Islandmore Wind Farm

Annex 14.1: Road Safety Audit

**Wind Farm Application, Toobrackan,
Ballaghaderreen, Co. Roscommon
Stage 1 Road Safety Audit**

Client:	Galetech Energy Services
Document No:	262305-ORS-XX-XX-RP-TR-13g-001 - RSA

Problem No. 01: Sightline Visibility at Bends

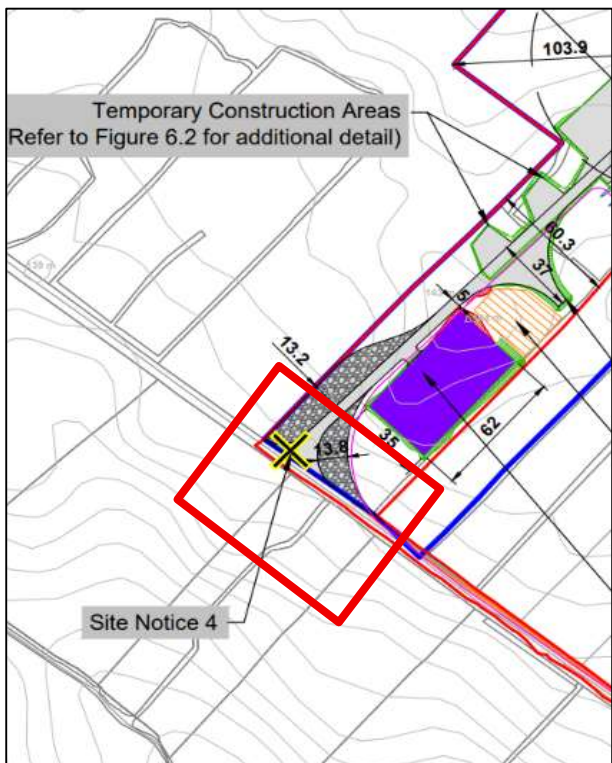
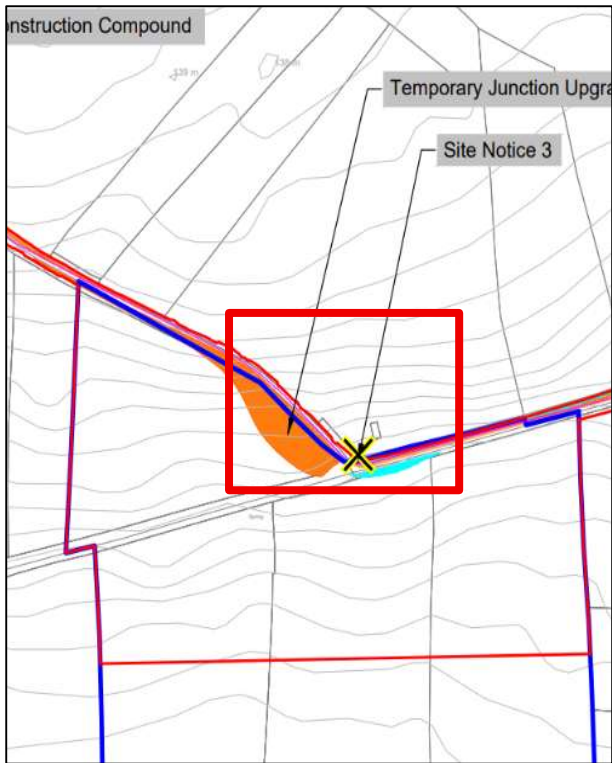
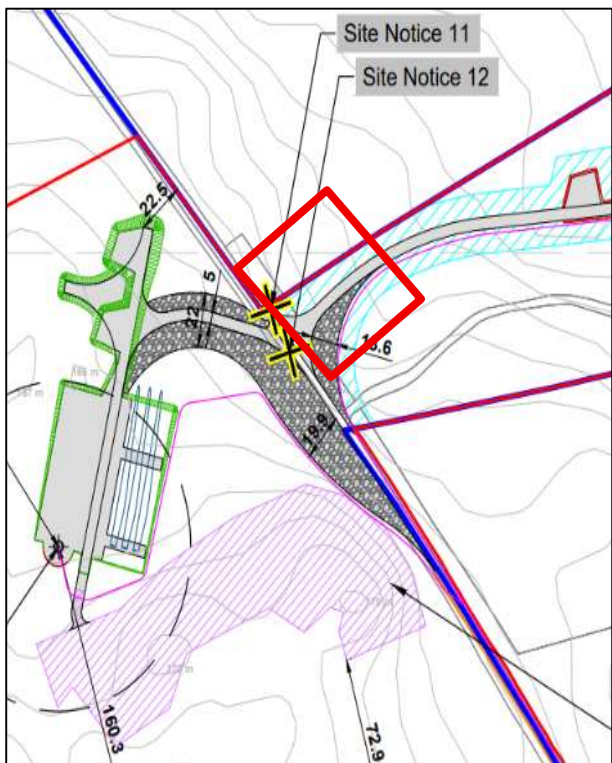
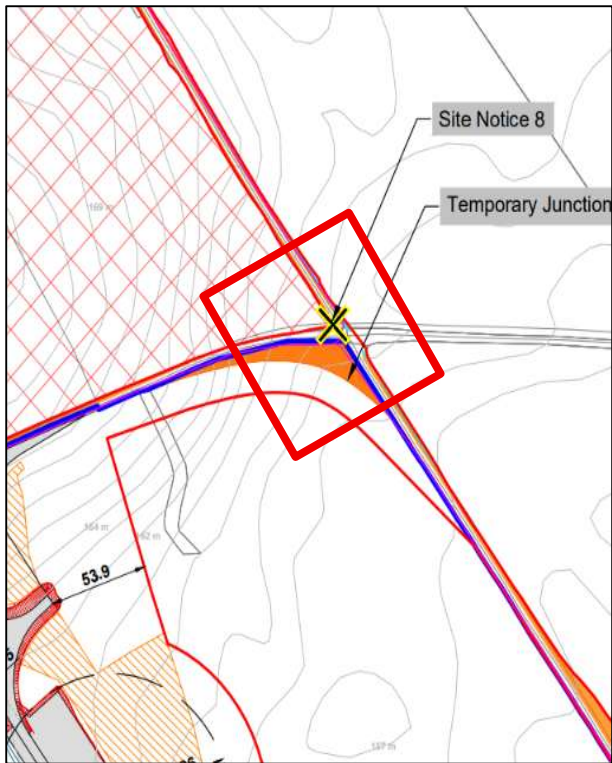
The audit team note from the site visit that visibility is restricted at a number of bends along the access route due to existing vegetation, hedgerows and/or roadside features. The audit team are concerned that restricted sightlines from the junction and forward visibility may prevent drivers from identifying approaching vehicles in sufficient time to react safely, particularly given the anticipated HGV movements associated with the proposed development.

The design team should ensure that adequate visibility is maintained at the locations identified and that any obstructions are removed or appropriately managed.

Problem Reference in Safety Audit Report	To Be Completed by the Designer			To be Completed Audit Team Leader
	Problem Accepted (Yes/No)	Recommendation Accepted (Yes/No)	Alternative Option (Describe) (Only complete if recommendation not accepted)	Alternative Option Accepted by Auditors (Yes/No)
P01	Yes	Yes. The site entrance and junction locations identified will be subject to permanent or temporary upgrade works which shall include improvements to visibility.		
P02	Yes	Yes. The proposed development provides for the widening of the carriageways of local roads as required. Verge markers and edge lining will be provided at required locations.		
P03	Yes	Yes. Four dedicated passing bays have been proposed while vehicular traffic will also be able to make use of proposed site entrances and forestry entrances for passing opportunities.		
P04	Yes	Yes. In addition to the dedicated passing bays, there are a number of other passing opportunities including at forestry and agricultural access points. A Traffic Management Plan will be prepared which will provide further detail on delivery schedules to minimise HGVs meeting along local roads.

Problem No. 02: Soft Verges Along Local Road on Approach Route

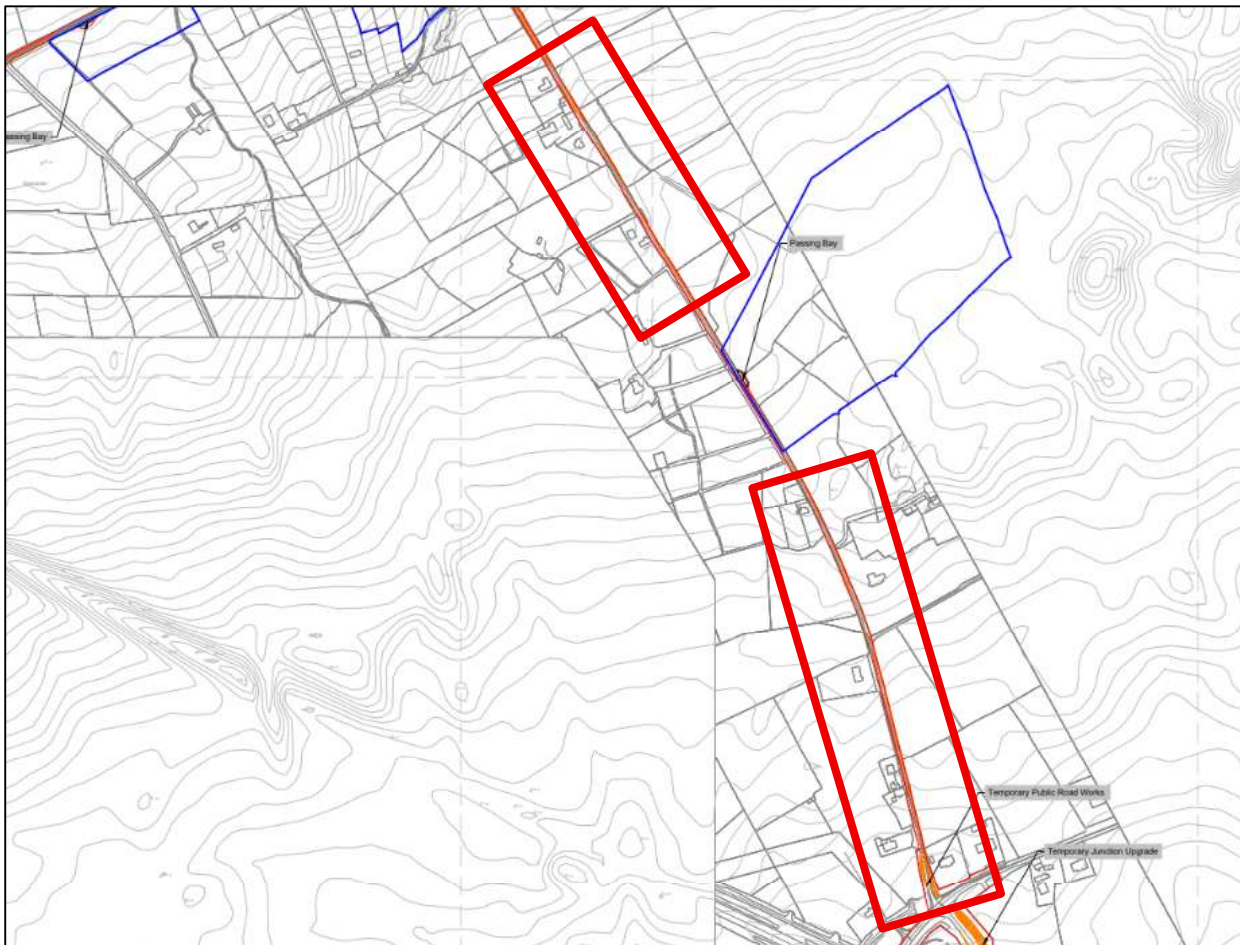
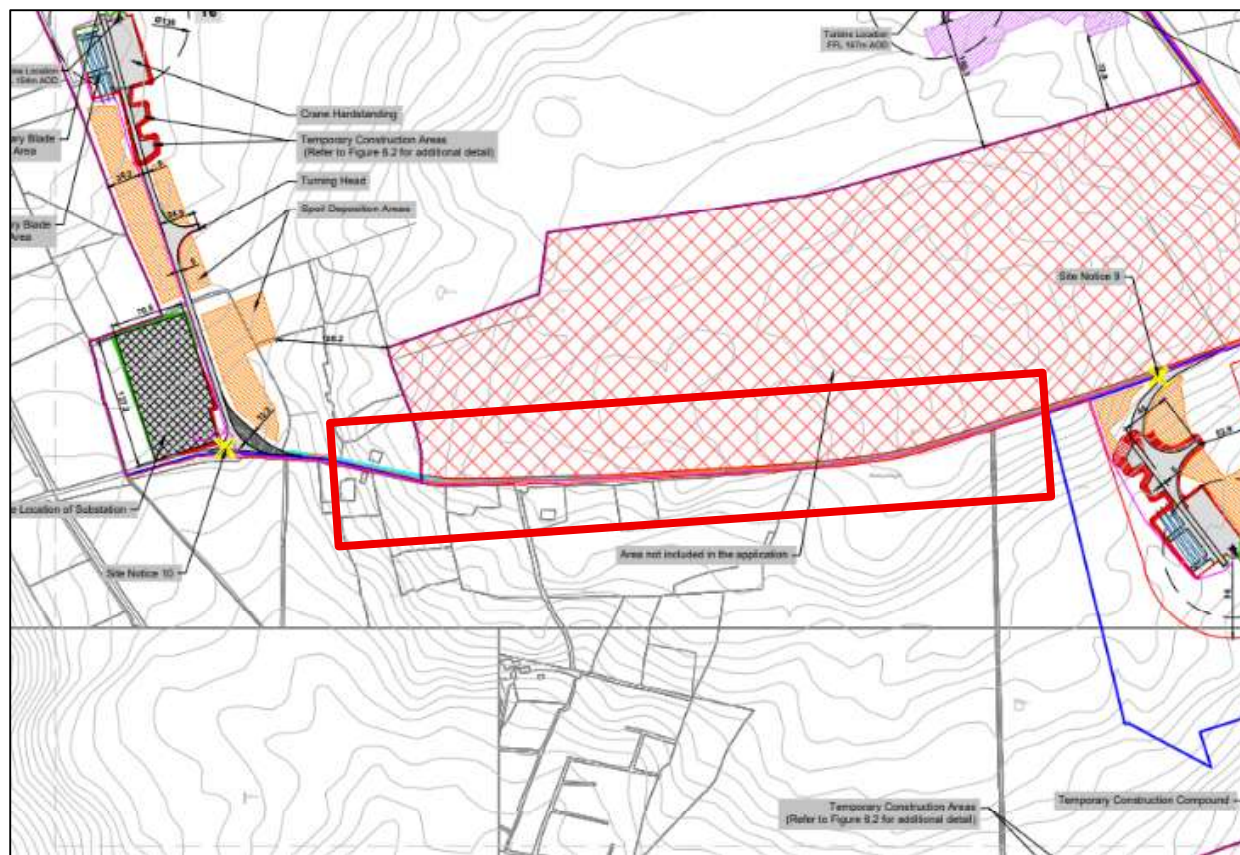
The audit team note from the site visit that there are areas of soft/boggy roadside verge along the proposed access route. The audit team are concerned that HGV and abnormal load vehicles may be required to overrun these areas when negotiating the narrow sections of road. This may result in vehicle instability, damage to the road edge or loss of control, increasing the potential for collisions.

The design team should ensure that the appropriate verge markers, edge lining is introduced. These photos are examples and checks should not be confined to these areas only.

Problem No. 04: Intervisibility between Passing Areas

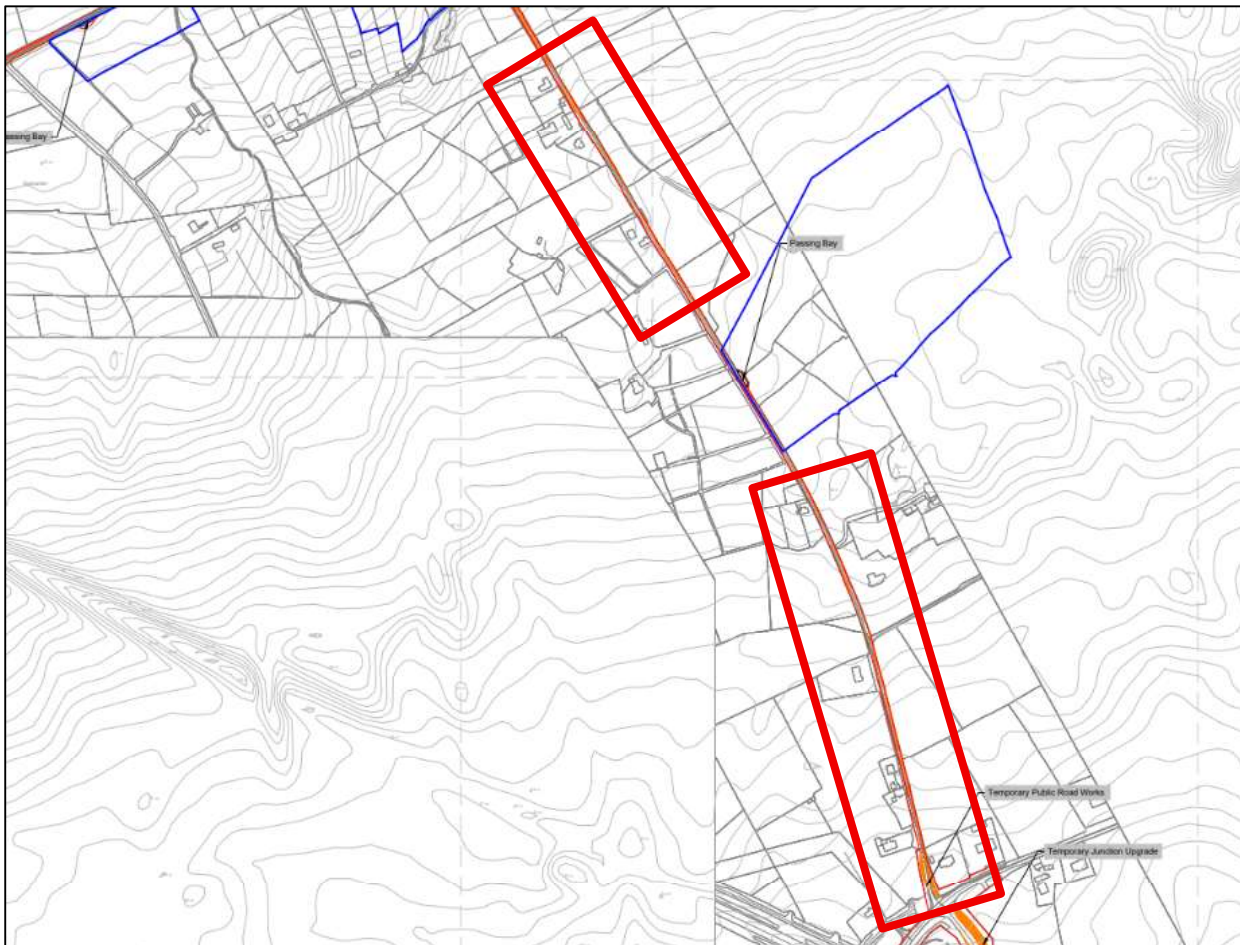
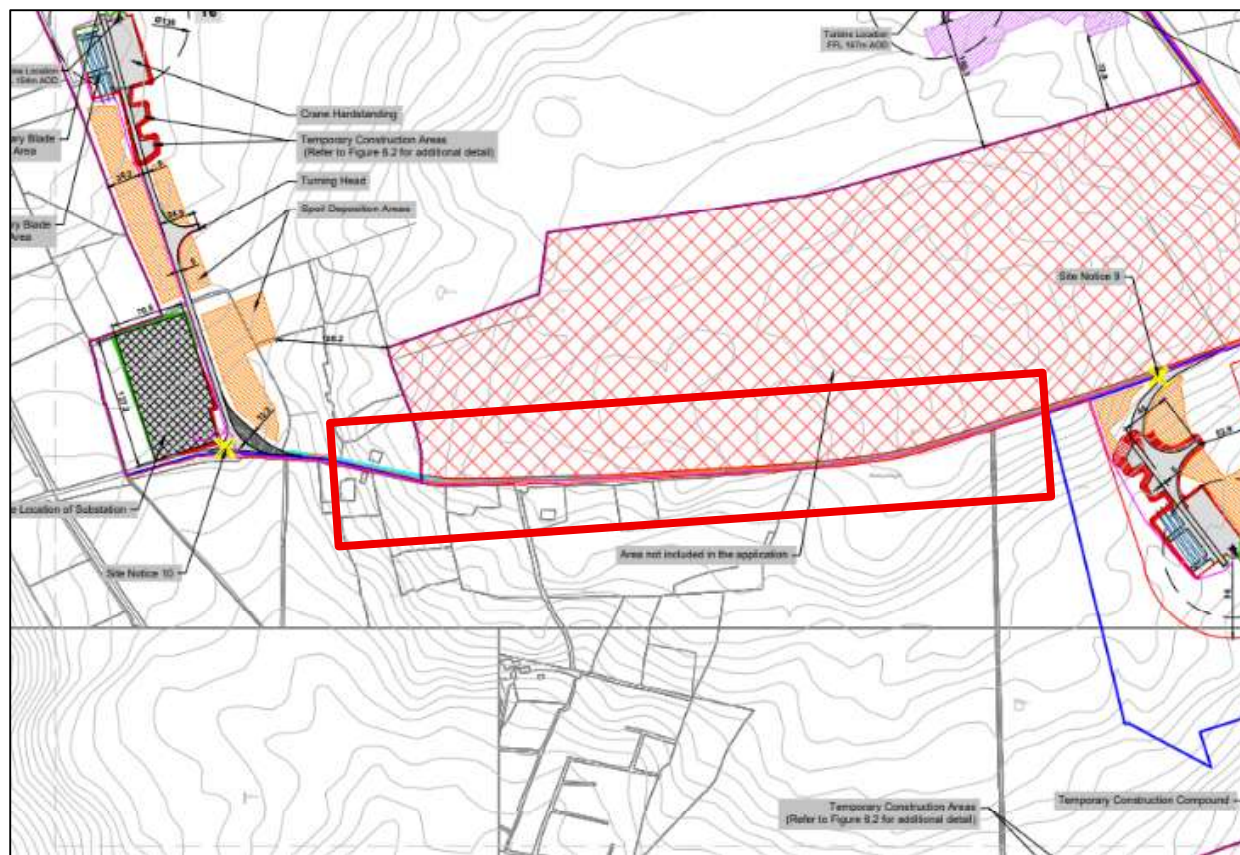
The audit team note from the drawings provided that it is intended to provide passing bays along the Local Road to ensure that large vehicles can safely pass one another due to the narrow nature of the existing road. However, it is unclear if appropriate intervisibility can be achieved from one passing bay to another to allow vehicles to safely stop in time to allow another vehicle to pass due to high ditches and vegetation along the Local Road.

The design team should ensure that clear visibility can be provided from one passing bay to another. The design team should also ensure that there is a dedicated Traffic Management Plan set out for the facility that provides dedicated delivery times for large vehicles to restrict the possibility of larger vehicles meeting along the Local Road.

Problem No. 07: Road Surface Condition**Location: Location Identified**

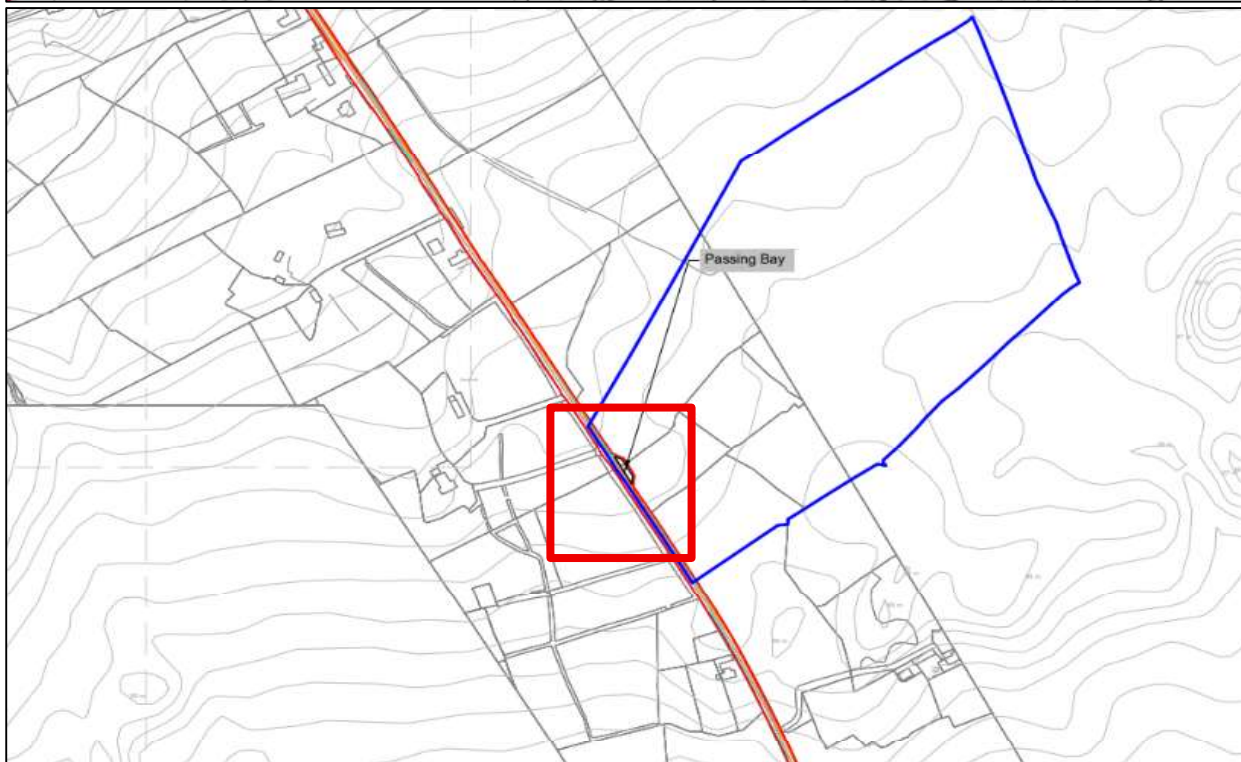
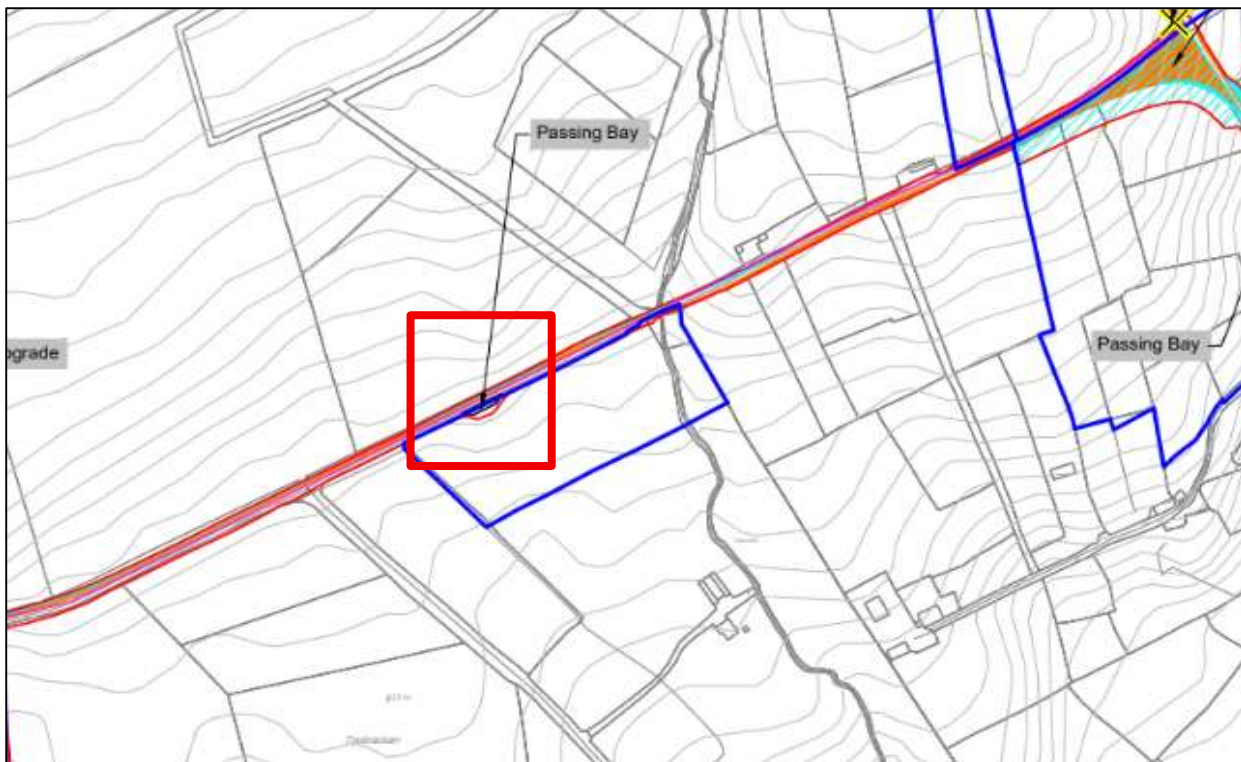
The audit team note from the site visit that the existing road surface appears to be in poor condition at the various locations along the route. The audit team are concerned that the increased HGV and abnormal load movements associated with the proposed development may accelerate deterioration of the existing road surface, potentially resulting in potholes, surface deformation and a reduced standard of road condition. This may increase the potential for loss of vehicle control and conflicts with other road users.

The design team should ensure that the existing road is of a suitable standard to accommodate the anticipated HGV and abnormal load movements associated with the proposed development. These photos are examples and checks should not be confined to these areas only.

Problem No. 09: Absence of Nacelle and Turbine Blade Swept Path Analysis

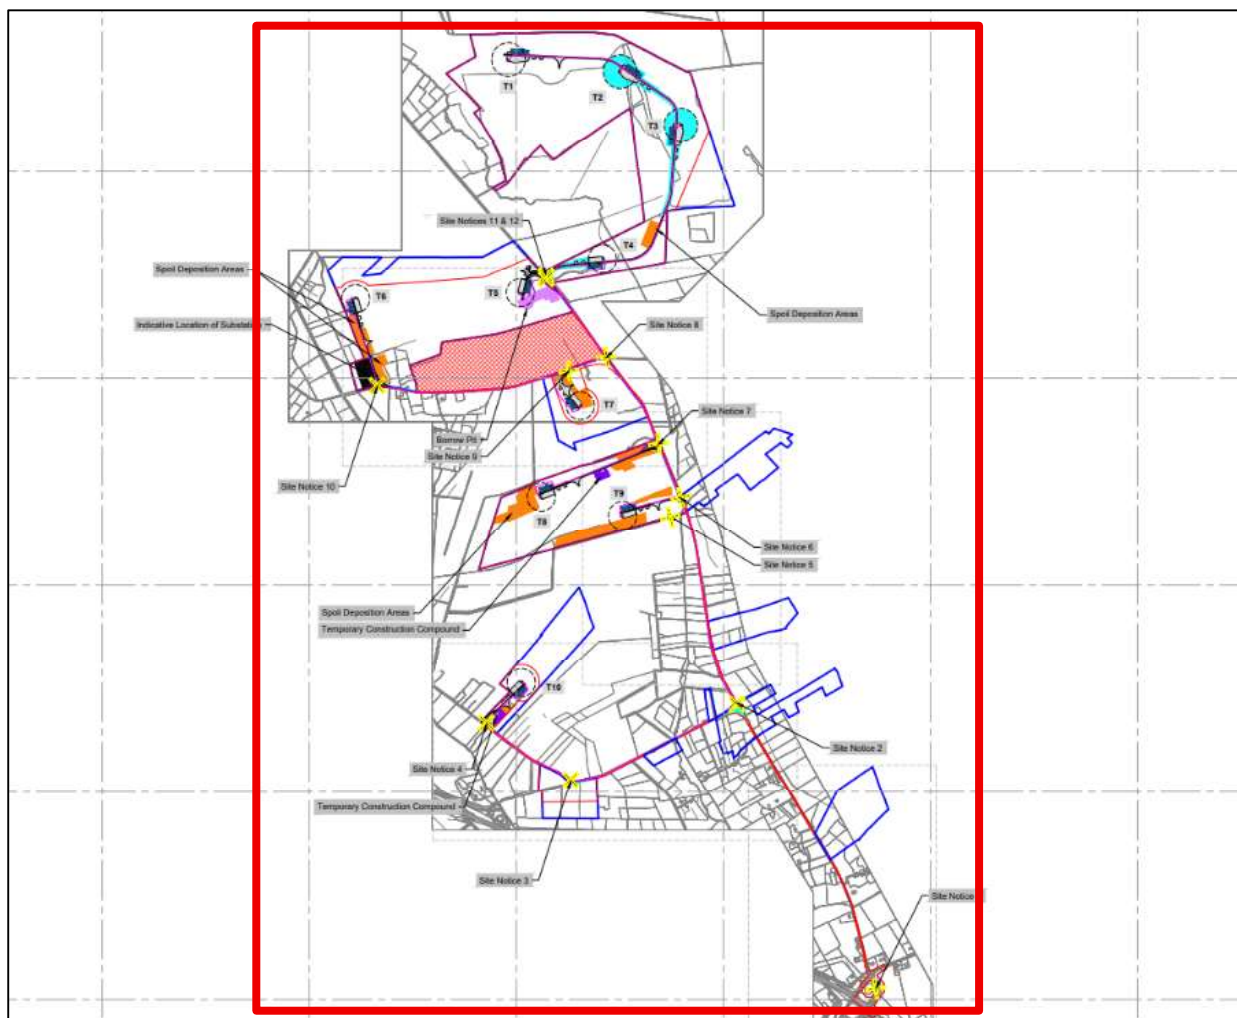
The audit team note from the drawings provided that no swept path analysis has been provided to demonstrate that the proposed turbine delivery vehicles can safely negotiate the identified locations along the delivery route. The audit team are concerned that the proposed turbine blades will extend beyond the trailer during transportation and that the associated blade oversail has not been demonstrated. This may result in the blade and/or delivery vehicle conflicting with existing roadside features, vegetation, drainage infrastructure, boundaries or other obstructions, potentially requiring additional road widening or clearance works.

The design team should ensure that a detailed swept path analysis is undertaken for the proposed turbine delivery components and the associated vehicles, including the nacelle full blade configuration and anticipated nacelle and blade oversail, to identify any locations requiring additional road/junction widening, passing bay provision, clearance or other mitigation measures.

construction, a number of haul route inspections will be carried out to ensure that all potential obstacles and hazards are removed.		
P06	Yes	Yes. As part of the proposed development, the identified junction will be subject to upgrade works. As part of the reinstatement of these works, all road markings shall be reinstated and made clearly visible.		
P07	Yes	Yes. The proposed development provides for the upgrading of the carriageways, as required, of local roads in the vicinity of the site prior to the commencement of construction. Similarly, post-construction, where any deterioration is identified and is directly attributable to the construction works, remedial measures/actions shall be undertaken.		
P08	Yes	Yes. As part of the post-consent detailed design process, appropriate drainage infrastructure shall be incorporated into the passing bay design.		
P09	No.	Yes. A detailed Route Access Survey has been conducted and the necessary works required to enable the delivery of turbine components to the project site are known and have been incorporated into the proposed development as required.
